Municipality of Anchorage

Subject: Case 2022-0026 Title 21 Text Amendment to Parking and Site Access Standards:
Issue-Response Summary

Title 21 Text Amendment to Off-Street Parking and Site Access Regulations

**Public Hearing Draft
PZC Case No. 2022-0026**

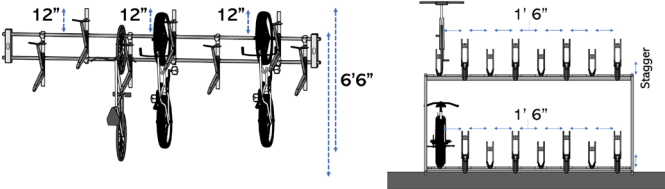
20.	<p>General Support for Pedestrian Provisions.</p> <p>Traffic Engineering concurs with the proposed amendments that support non-motorized modes of transportation. These amendments will provide greater assurance that developments have all required amenities to support these alternative transportation strategies. <i>(Traffic Engineering Department)</i></p> <p>Bike Anchorage strongly supports the proposed code changes to increase the baseline requirements for bike parking in new development, require secure parking for long-term bike storage, and ensure usability of bike parking facilities, as well as the option to replace required car-parking with additional bike parking. <i>(Bike Anchorage)</i></p> <p>Support for the proposed updates that clarify and consolidate design standards for sidewalks and on-site pedestrian walkways, increasing bicycle parking space requirements. <i>(Anchorage Public Transit Advisory Board)</i></p> <p>The bicycle parking requirement changes are exciting, and I look forward to implementing them. <i>(Connor Scher)</i></p>	<p>Response: Staff appreciates the comments of support. These comments are consistent with feedback in staff heard at public meetings and consultations support of improving pedestrian facilities.</p> <p>RECOMMENDATIONS: No changes.</p>

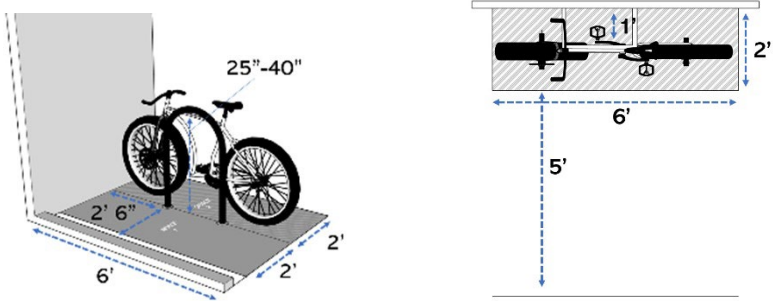
Item #	Comment/Question	Response and Recommendation	PZC Action															
21.	<p>Maximum Front Setbacks.</p> <p>Table 21.07-2 sets the proposed Pedestrian Frontage Standards for Traditional Urban Neighborhood Contexts including South Addition. The maximum setback in the table is a tenuous concept for South Addition, for several reasons. It does not provide specific exemptions for properties. It does not address existing, older residential buildings that may be remodeled. It does not address lots that are located along the Chester Creek bluff in South Addition and Fairview, especially lots without alley access. Similar bluff conditions exist in Mountain View and Government Hill as well. The lots in Traditional Urban Neighborhoods are smaller and need to allow the designers to use their best judgement to locate buildings on the lot. For example, a west or south facing frontage may want to pull the building back all the way towards the back where garage access exists from the alley. Such building can still have "eyes on the street" (i.e., street-facing windows, entries, and living spaces) even if it is set back farther. The most important feature to avoid on the street is large garage frontages. (<i>South Addition Community Council Planning Subcommittee</i>)</p> <p>Will a porch, stoop, or landing sheltered by a roof count towards meeting the maximum front setback requirements? Will the porch be allowed to project into the minimum front setback? (<i>Connor Scher</i>)</p>	<p>Response: No objection to removing the maximum setback from the low- to medium-density residential zoning districts. The maximum setback is more important in the urban commercial districts, mixed-use corridors, and high-density R-4 residential district. (Maximum setbacks in the R-4A district are addressed in the R-4A district-specific standards.) The proposed maximum setbacks are carried over from current code for mixed-use development in the commercial districts, as well as from the current Title 21 approval criteria for area-specific parking reductions. Fairview Community Council in consultations emphasized that buildings should be required to be set close to the street, as called for in the <i>Fairview Neighborhood Plan</i>. The <i>Spenard Corridor Plan</i> also calls for pedestrian-oriented building placement.</p> <p>Maximum setback regulations in Title 21 address existing buildings. The general provisions for maximum setbacks in Section 21.06.030C.5. recognize that existing buildings may remain legally out of compliance.</p> <p>The maximum front setback applies to the building elevation wall. Covered entry porches but not stoops or landings may also count toward meeting a maximum front setback. Because the maximum front setback is 10 to 20 feet larger than the minimum front setback and applies to no more than 50% of the building façade width, there is plenty of space between the max. and min. to avoid a “catch-22” situation for front stoops.</p> <p>RECOMMENDATION: Amend Section 21.07.060F.3, Table 21.07-2 (page 14 of Attachment 3), in row “A,” and delete footnote 4, as shown below. (Also delete the references to footnote 4 from rows B and G.)</p>

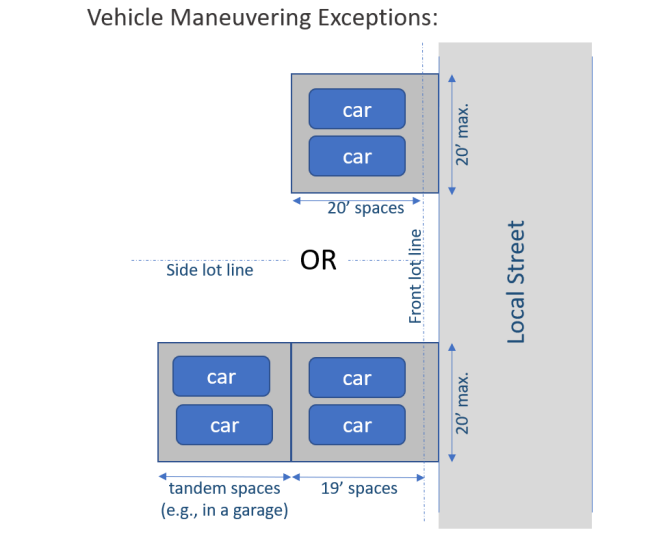
36.	<p>Determining which Parking Spaces on a Site Plan are Eligible for Small Dimensions.</p> <p>Traffic Engineering is appreciative of the changes made to the parking angle, stall, and aisle dimensions, however has concerns with proposed exception 21.07.090H12.a.ii. (Page 58 in Attachment 3) that allows for 50% of spaces to be smaller dimensions for employee only, structured parking facilities, and low parking uses. This provision may need additional</p>	<p>Response: The comment comprises three main questions:</p> <ol style="list-style-type: none"> 1. What defines low turnover uses; 2. How are the spaces for low turnover uses to be identified; and 3. Can the Municipality require them to be called out in a parking study on the plan? <p>The second and third questions are addressed during the permitting approval process for the site plan. The proposed parking layout site plan should identify which spaces serve low-turnover uses and have smaller dimensions. If the low-turnover parking spaces are not shown on the site plan, and the parking study (if there</p>

Item #	Comment/Question	Response and Recommendation	PZC Action
	<p>clarification regarding which spaces on a site plan are designated as either employee only or low turnover for both municipal staff who review plans and design professional that develop the site plan. <i>(MOA Traffic Engineering Department)</i></p>	<p>is one) does not address the number of spaces, then that should be a permit reviewer comment. Asking for clarification on a parking layout plan or site plan is common practice by zoning plan reviewers.</p> <p>The answer to question 1 above seems apparent in the second sentence in 21.07.090H12.a.ii. (Attachment 3, page 58, lines 27-30). However, perhaps a simple word change, as provided below, could make it clearer.</p> <p>RECOMMENDATION: Clarify proposed subsection 21.07.090H12.a.ii. (Page 58, lines 27-30, in Attachment 3) as follows:</p> <p style="padding-left: 40px;">Uses with a low parking turnover rate are[COMPRISE] multifamily and mixed-use household living uses, office uses, and educational facility uses other than instructional services.</p>
